BROOKHAVEN NATIONAL LABORATORY
MEMORANDUM

DATE: March 27, 1985
TO: K. Perkins
FROM: L. J. Teutonico
SUBJECT: FIN A-3786 - Study of Beyond Design Basis Accidents in Spent Fuel Pools

FIGURE 1 CORRELATIONS FOR ZIRCONIUM OXIDATION IN AIR
(FROM REF. 1)

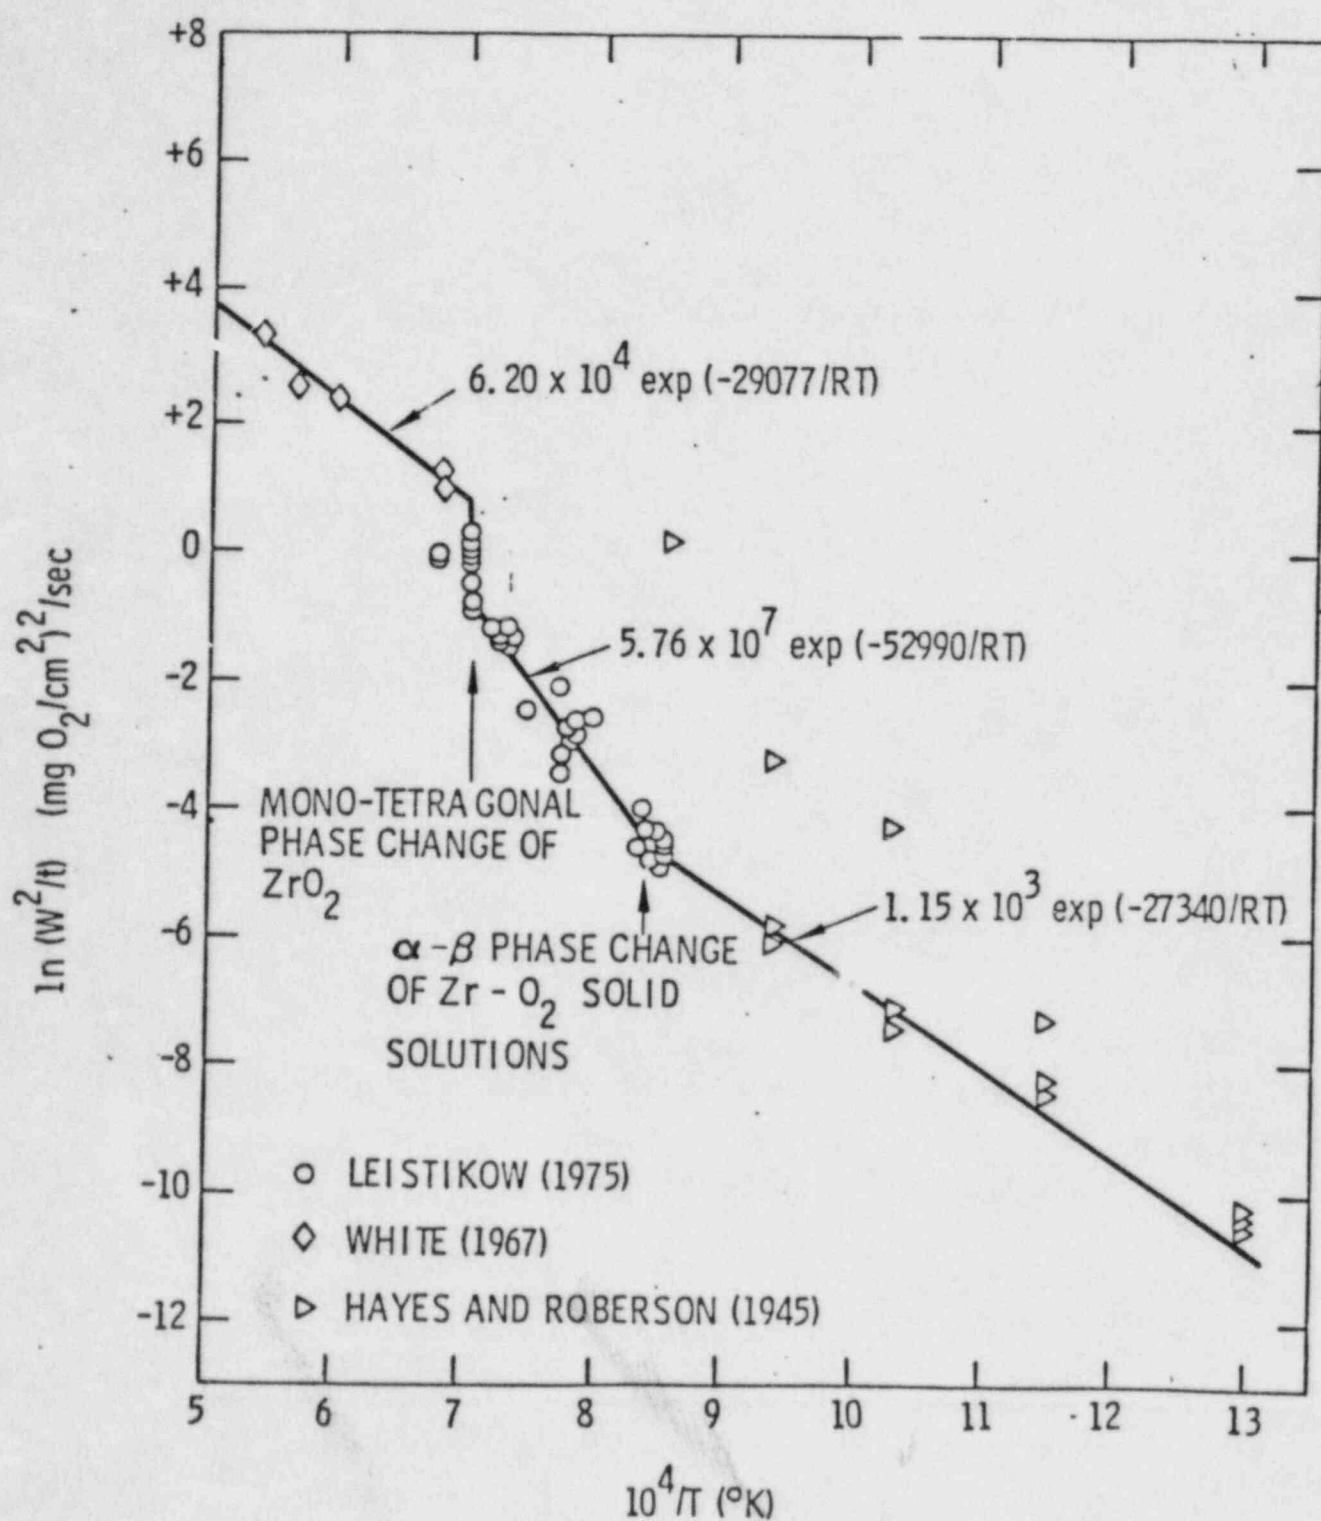
A. Experimental Data: A literature search ⁴⁻¹⁴⁷ has revealed that there is a great deal of data for zirconium oxidation; most of it, however, is concerned with oxidation in steam or oxygen. The data for zirconium (zircaloy)-air oxidation presented in Refs. 1 and 2 appear to be the best available. These are shown in Figure 1. The authors (of the SNL reports) fit the data with three separate Arrhenius plots over the temperature range 500-1500°C; one break occurs at the α - β transformation temperature for zirconium, the other at the temperature at which the oxide undergoes a monoclinic-tetragonal transformation. (N.B. two of the sets of data are for zirconium, the other for zircaloy-4). These assumptions are reasonable. It should be noted, however, that there is no a priori reason to expect that the data would be fit by an Arrhenius expression, particularly above the α - β transformation temperature where a number of different processes are occurring simultaneously (discussed further below); therefore the use of the Arrhenius expression should be viewed in this case only as a computational tool. It is difficult to assess the validity of the data employed. What are really required are new experiments to determine the oxidation rate of zircaloy in air over the temperature range of interest, for both isothermal and non-isothermal conditions.

FIGURE 2 PARABOLIC RATE CONSTANTS FOR OXIDE LAYER GROWTH, α -LAYER GROWTH, AND OXYGEN CONSUMPTION FOR THE REACTION OF ZIRCONIUM (SOLID LINES) AND ZIRCALLOY-4 (DASHED LINES) WITH STEAM. THE RATE CONSTANTS FOR OXYGEN CONSUMED (WEIGHT GAIN) WERE DETERMINED FROM MODELING ANALYSES (FROM REF. 136).

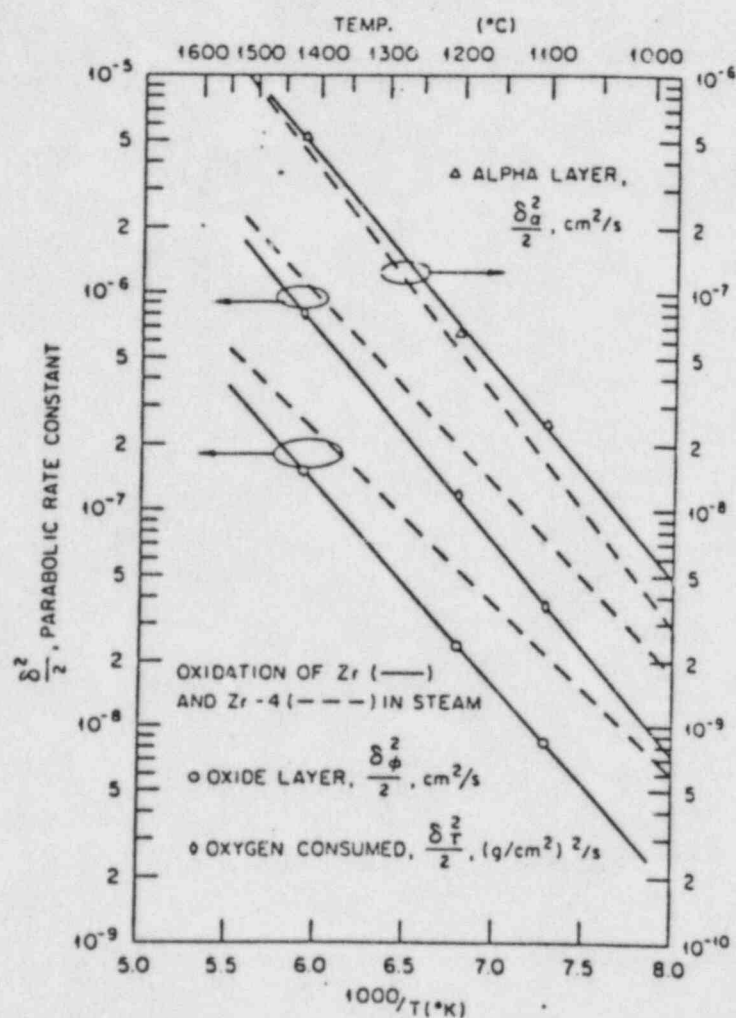
C. Zirconium vs. Zircaloy: It is assumed in the Sandia work that the oxidation rates of zirconium and zircaloy are essentially the same. Recent work by Pawel and Campbell¹³⁶ has shown that this is not the case. Oxidation in steam of both pure zirconium and zircaloy-4 was studied in the temperature range of rapid oxidation (1000°C-1500°C). It was found that at all temperatures the oxidation rate of zircaloy-4 was higher than that of zirconium; the ratio of the two rates is approximately 3 at 1000°C and decreases with increasing temperature to a value of approximately 1.5 at 1500°C (cf. Figure 2). The higher oxidation rate of Zircaloy-4 is attributed to increased oxygen diffusivity in the oxide phase; a lower activation energy was observed, implying that some mechanistic differences exist. Analogous results are expected to apply for oxidation in air.

D. Oxidation Model: The oxidation in steam of both zirconium and zircaloy-4 (in the temperature range 1000-1500°C) is a multi-phase layer process.¹³⁶ Not only is an oxide layer formed, but also (beneath it) a layer of oxygen-stabilized α -phase (zirconium or zircaloy). The multi-phase model is only significant above the α - β transformation temperature (approximately 900°C), but this is exactly where rapid oxidation occurs. The parabolic rate constants for oxide layer growth, α -layer growth, and oxygen consumption were determined in Ref. 136 from experimental data and computer modeling. The rate of oxygen consumption is significantly higher at all temperatures than the rate of oxide formation for both zirconium and zircaloy-4. For zirconium the ratio of oxygen consumption rate to oxidation rate is approximately 4 at 1000°C and increases with increasing temperature to a value of approximately 5.4 at 1500°C; for zircaloy-4 the corresponding values are approximately 3.0 and 4.5 at 1000°C and 1500°C, respectively (cf. Figure 2). Although these results were obtained for oxidation in steam, analogous results are again expected for oxidation in air.

In sum, there are a number of uncertainties associated with the zircaloy-air reaction equation. These are particularly important above $900^\circ C$ where rapid oxidation occurs. The most significant appear to be (i) the difference in the oxidation rates of zirconium and zircaloy, and (ii) the multiphase nature of the oxidation process itself at these temperatures. The results given above in Section C and D (i.e. for zirconium vs. zircaloy-4, and oxygen consumption rate vs. oxidation rate, respectively) apply to oxidation in steam only. Analogous results are expected for oxidation in air, i.e. it is expected that the oxidation rate in zircaloy will be greater than that in zirconium, and the rate of oxygen consumption will be greater than the rate of oxide formation in both materials. The relative magnitude of these effects cannot be deduced from the steam oxidation data. What are required are new experiments and computer modeling (similar to those carried out by Pawel and Campbell¹³⁶ for oxidation in steam) for the high temperature reaction of zirconium and zircaloy with air. In lieu of these, we suggest that additional calculations be performed for two other zirconium-air reaction correlations which will serve as bounds for those presented in Figure 1. (a) The high temperature correlation for zirconium (above the phase change of ZrO_2) should be multiplied by a factor m_1 to account for the higher reaction rate in zircaloy. (b) The correlations above the α - β transformation temperature should be divided by a factor m_2 to account for the difference in oxygen consumption rate and rate of oxide formation. Values of m_1 and m_2 as large as five should be considered.
